## ADDENDUM NUMBER 4

Project Number 89020267 TAP-3324 (411)

Project Title (Reissue) Rte. 152 Trail – Seg. 10 Pedestrian Bridge over

ISSUE DATE: 06/30/2026

**EAST WALL  
 PLAN & PROFILE**

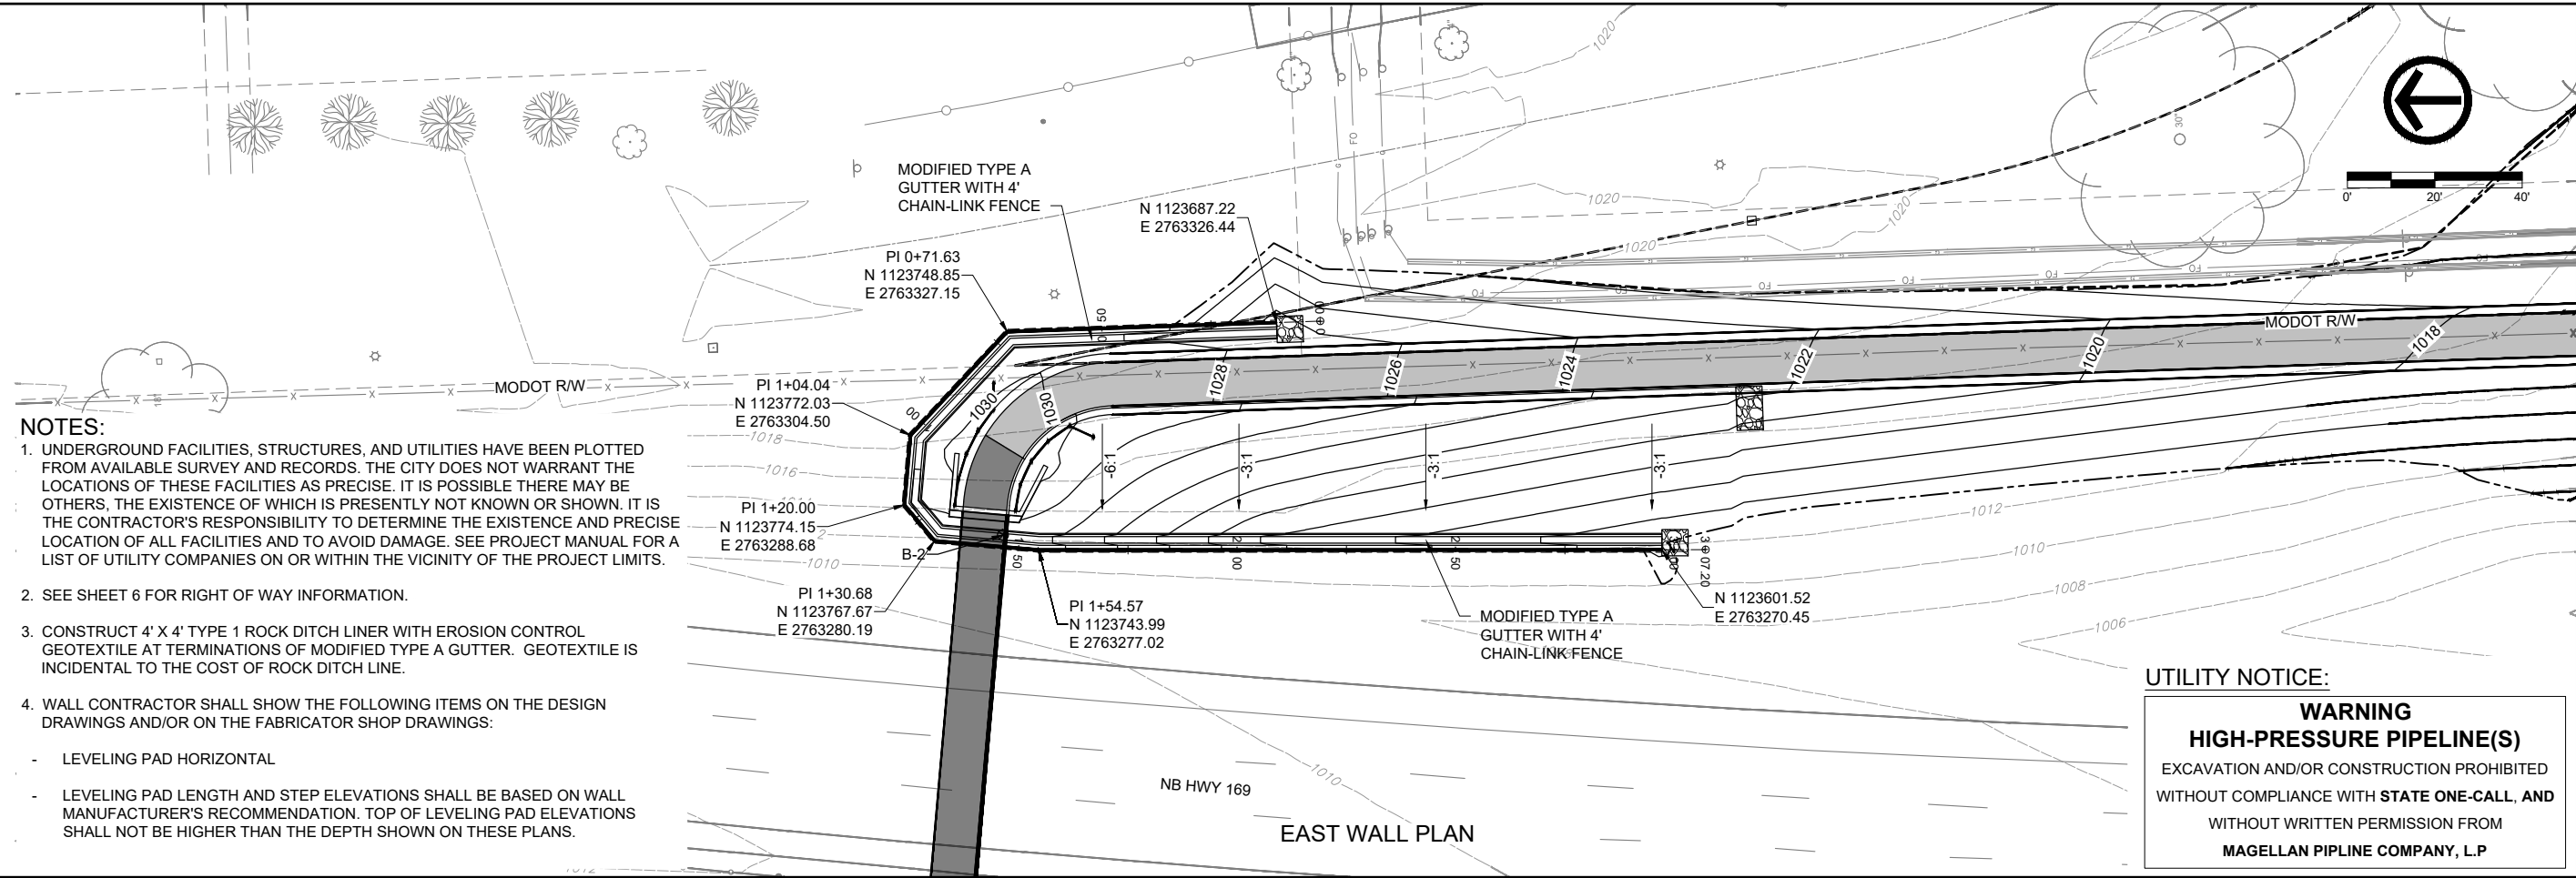
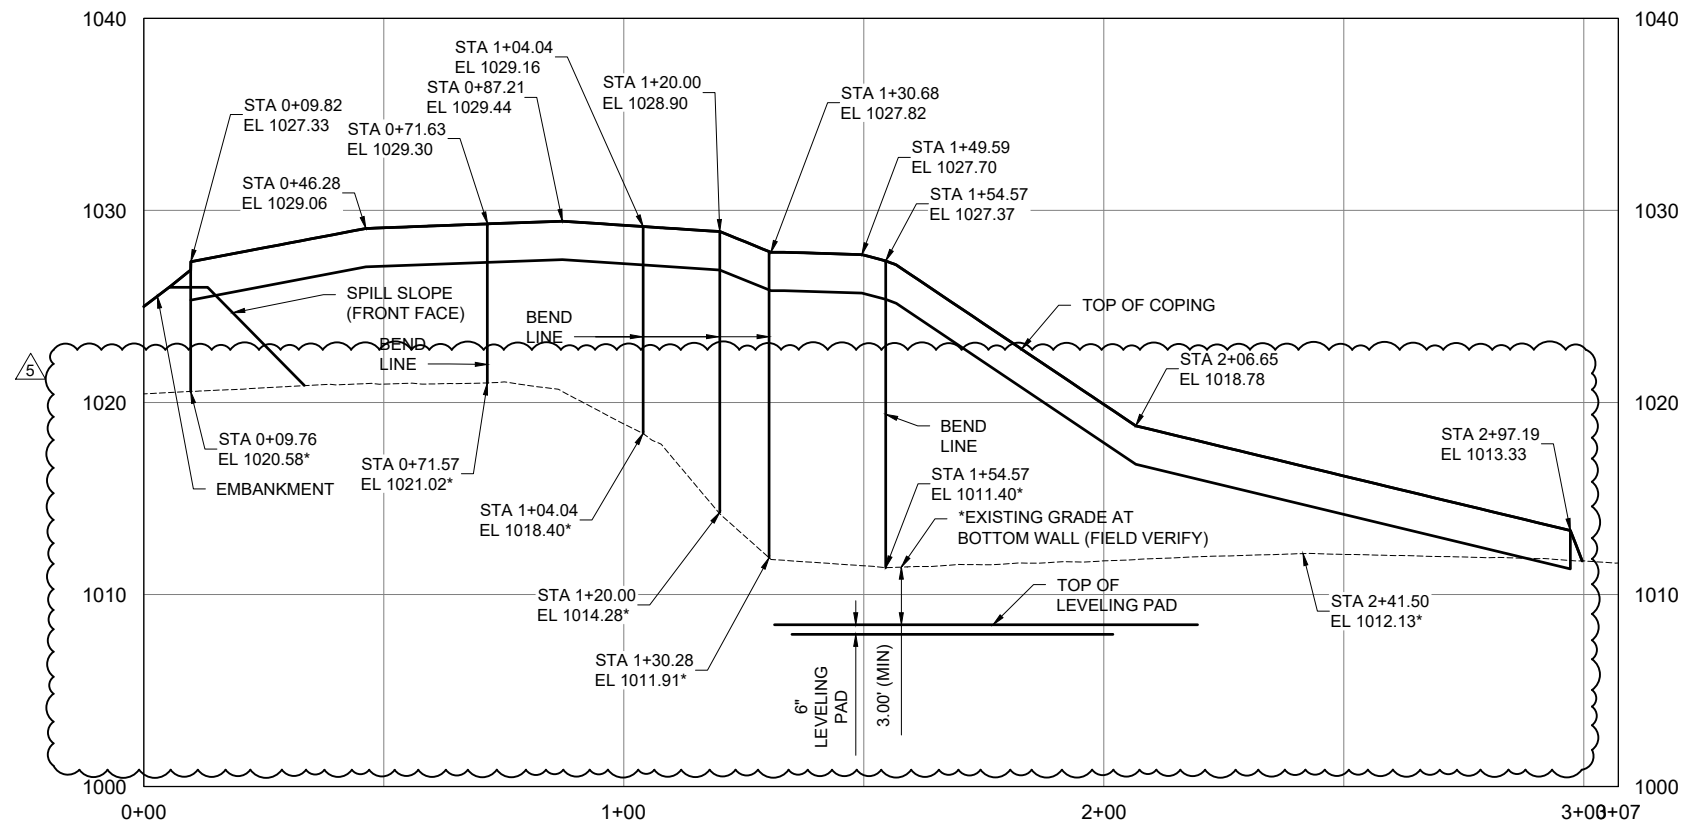
20. Can stationing and elevations for the MSE wall leveling pad and finished grade line be provided? Please see revised plan sheets W1 and W2 depicting stationing and bottom elevations for the proposed finished grade at the wall face or top of leveling pad.

*Leveling pad elevations are set by the manufacturer based on an economic arrangement of the wall pieces. Contractors are to place the depth based on the parameters set on the plans. Also, the "proposed" groundline is the "existing" groundline and the contractor should verify it since it has been years since it was surveyed. (See Page 5 and Page 6 for W1 East Wall and W1 West Wall)*
